FINAL Findings Report
Small Arms Range
Lake Housing Area

SENECA ARMY DEPOT ACTIVITY (SEDA)

FINAL Findings Report
Small Arms Range, Lake Housing Area
SEAD-119B

Response to the Comments from the U.S. Environmental Protection Agency

**FIGURE 2-3
GRIDS SET FOR GEOPHYSICAL SURVEY
AT THE SMALL ARMS RANGE**

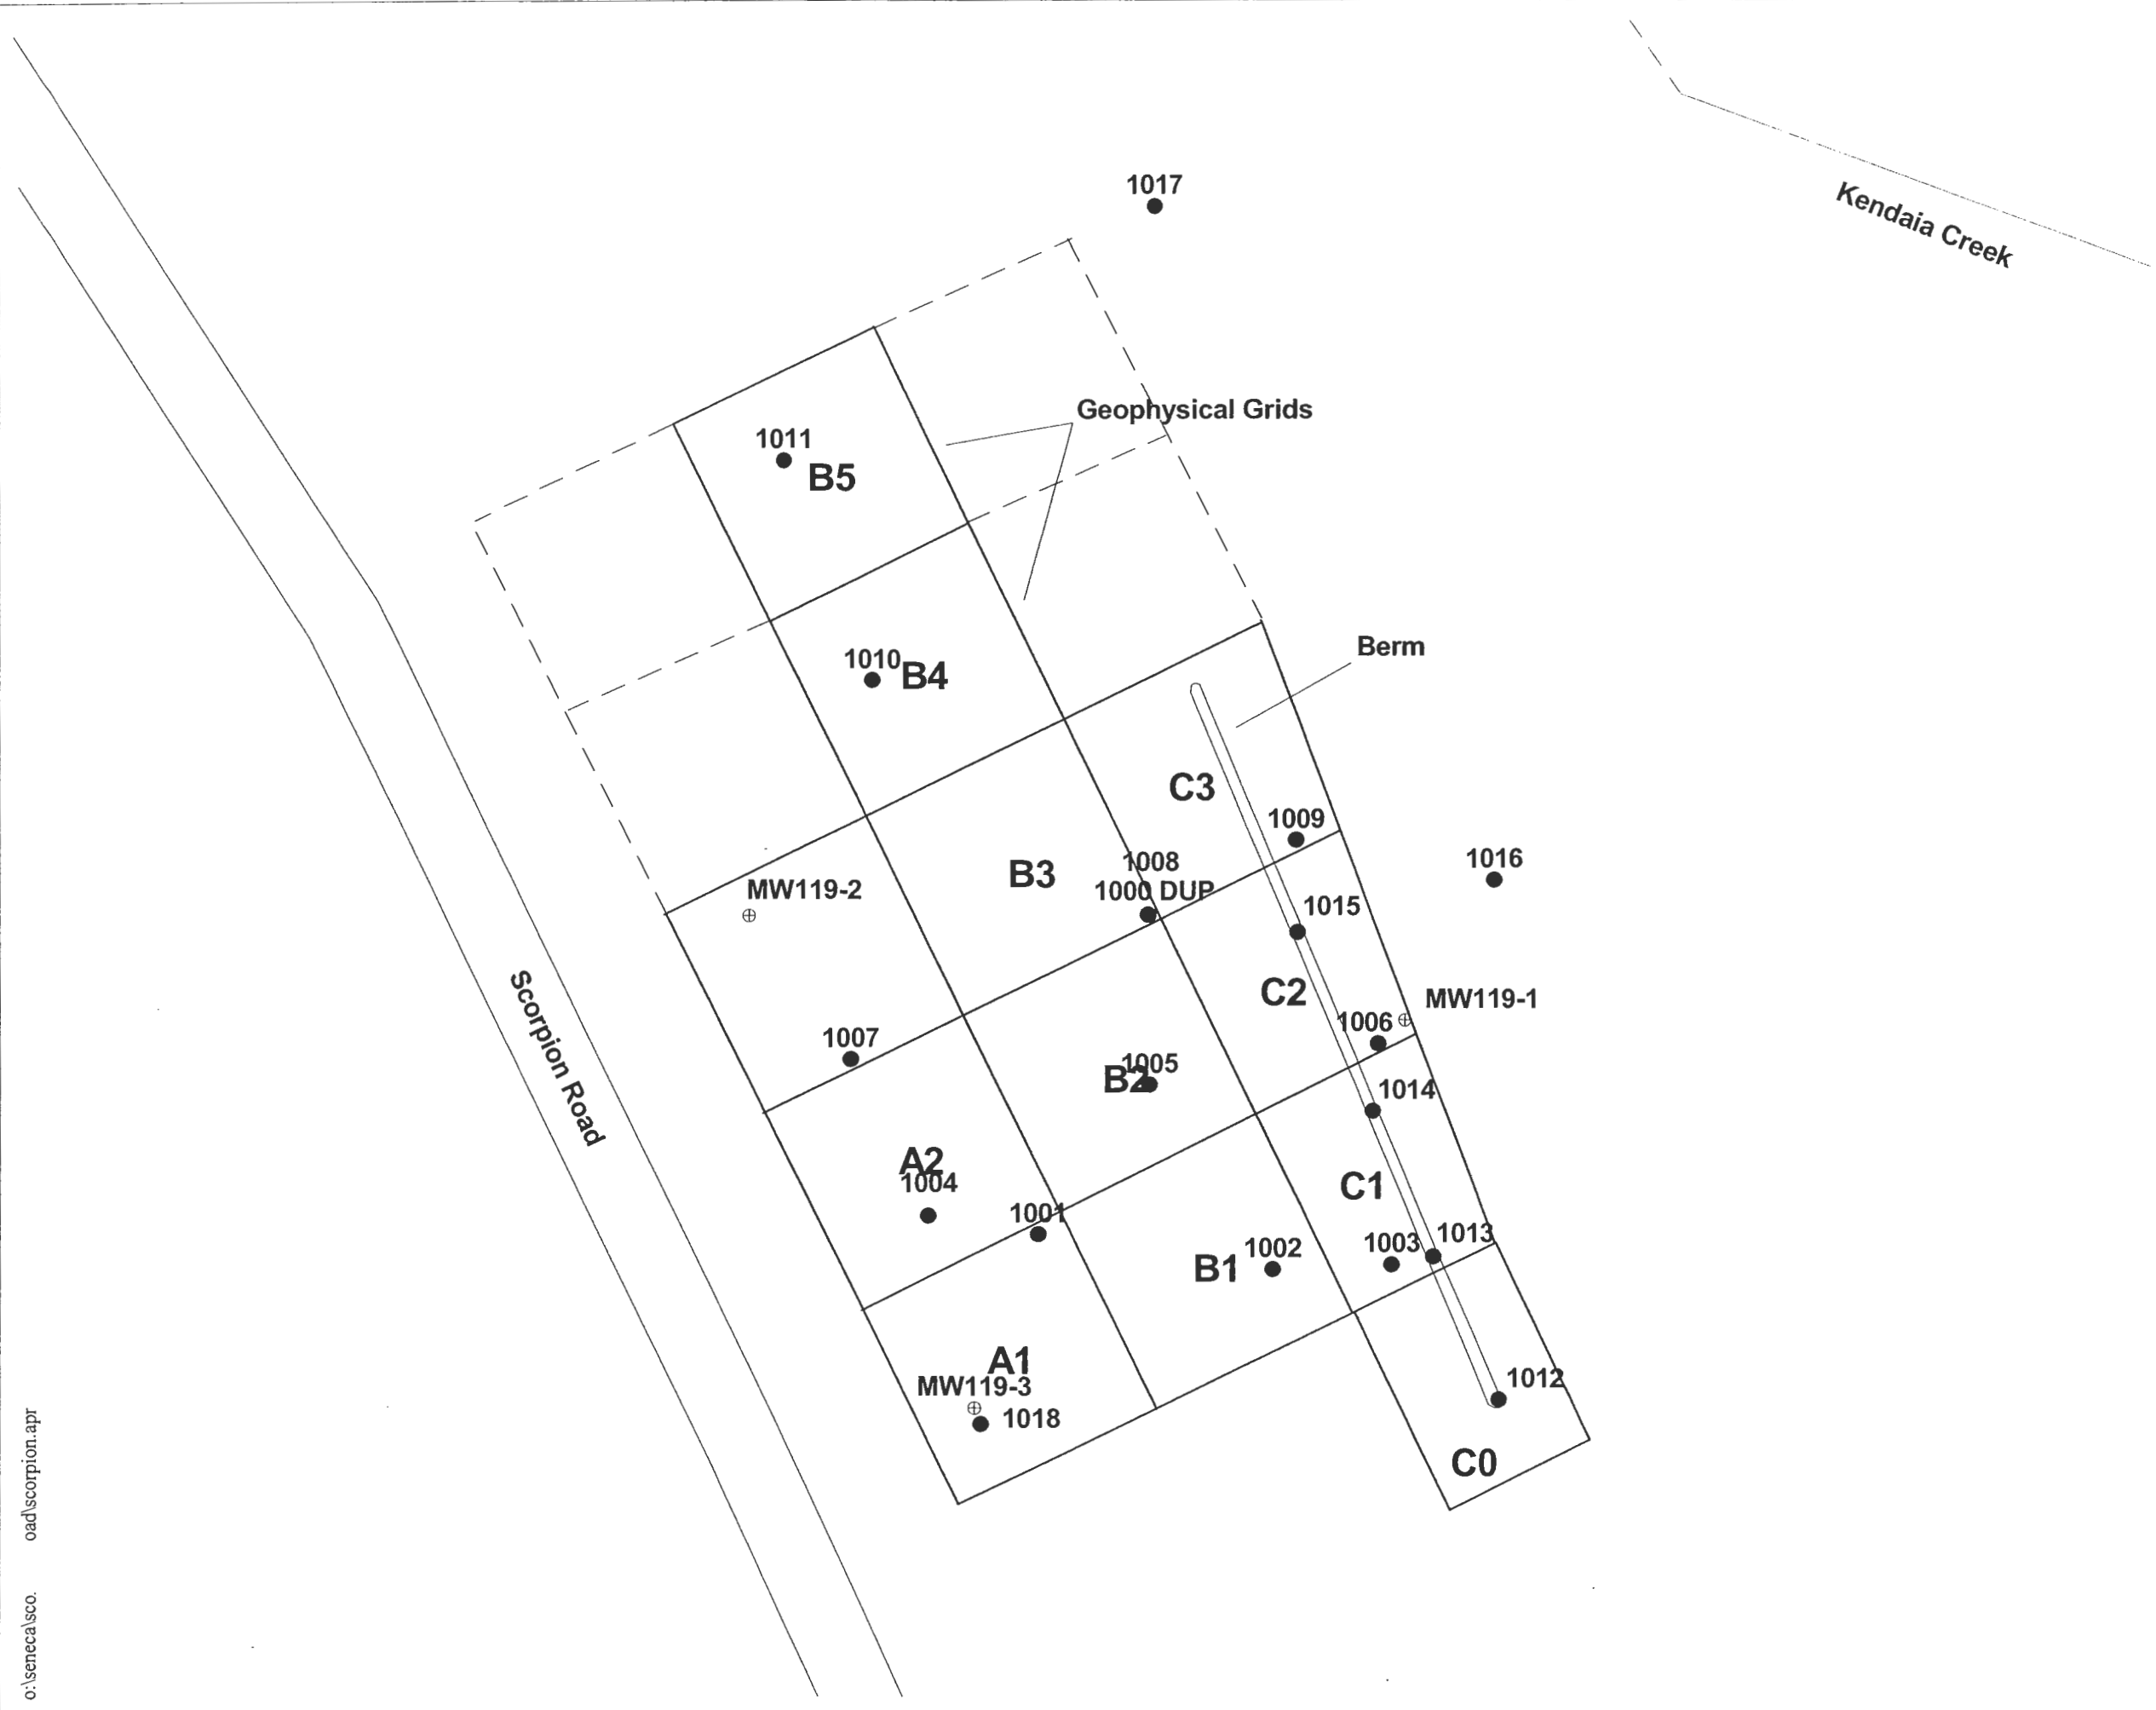
6. **Figure 2-3.** Revise this figure to indicate the general topography of the site.

Response: Acknowledged. It should be noted that the general topography of the site and its vicinity is shown in Figure 2-2 of the report. No map showing the detail topography of the suspected Small Arms Range (i.e., with relatively low interval for the elevation contour) is available.

FIGURE 2-4
MONITORING WELL AND
SURFACE SOIL SAMPLE LOCATIONS

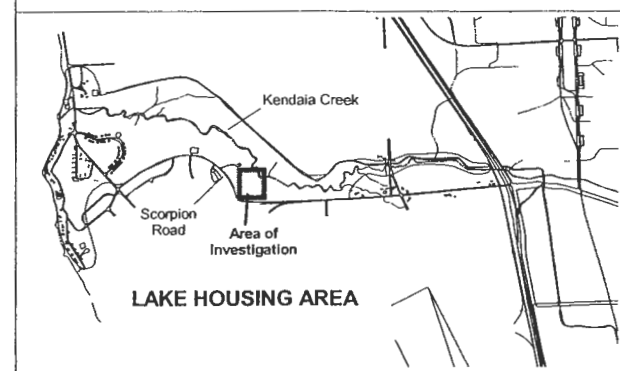
7. **Figure 2-4.** Revise this figure to include the direction of groundwater flow at the site, as well as general topography.

Response: Acknowledged. As discussed in the preceding response, no map showing the detail topography of the suspected Small Arms Range (i.e., with relatively low interval for the elevation contour) is available. Groundwater elevations were not measured and therefore, groundwater direction was not shown on Figure 2-4. As discussed in Section 2.4.3.3 of the report, both USEPA and NYSDEC approved the Army's request that groundwater sampling and analysis requirement be waived for this site. It should be noted that preliminary groundwater elevation data collected during the development of the wells indicate that the local groundwater flows from the area of Scorpion Road northeast towards Kendaia Creek.

**FIGURE 3-1
RESULTS OF GEOPHYSICAL SURVEYS
AT THE SMALL ARMS RANGE**

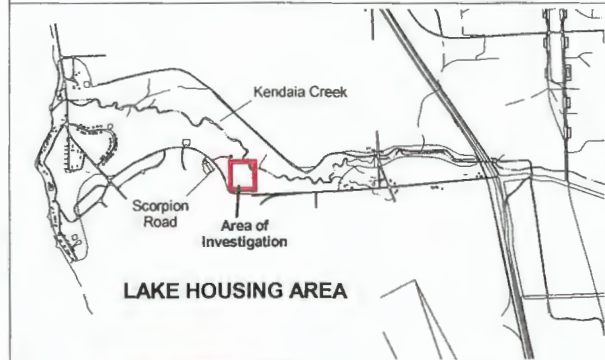
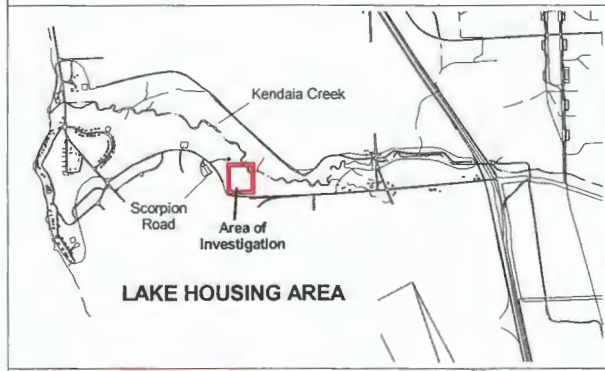
4. **Section 3.1, Geophysical Results, Page 3-1.** The discussion of results of the geophysics indicates that “anomalies greater than 80 mV are present...” within the investigation grid. However, review of Figures 3-1 and 3-2 shows results no higher than 10 mV, as represented by pink shading. If the scale on the figures was somehow zeroed to the data, please indicate this in the text. If not, clarify the reference to 80 mV in the text or correct the scale on the figures, whichever is appropriate.

8. **Figures 3-1 and 3-2.** Please clarify the anomalies identified as "steel pipes" on these two figures. Are these the same objects that are referred to as "metal posts" in the Physical Site Characterization in Section 2.3? If they are different objects, revise the text to provide a description and presumed purpose of these steel pipes.
-

Response: Acknowledged. It should be noted that Figure 3-1 provides contour with EM-61 response equal to or greater than 10 mV, as anything above 10 mV is generally not expected at a small arms range. The contour with EM-61 response equal to or greater than 80 mV is not presented in the figure. The scale in Figures 3-1 and 3-2 has been revised to reflect the above discussion.

Response: Acknowledged. The steel pipes and metals posts are the same objects. The Army believes that these pipes may have once been used either to hold target lines or to mark firing lines. Figures 3-1 and 3-2 and the text have been revised to reflect the above discussion.
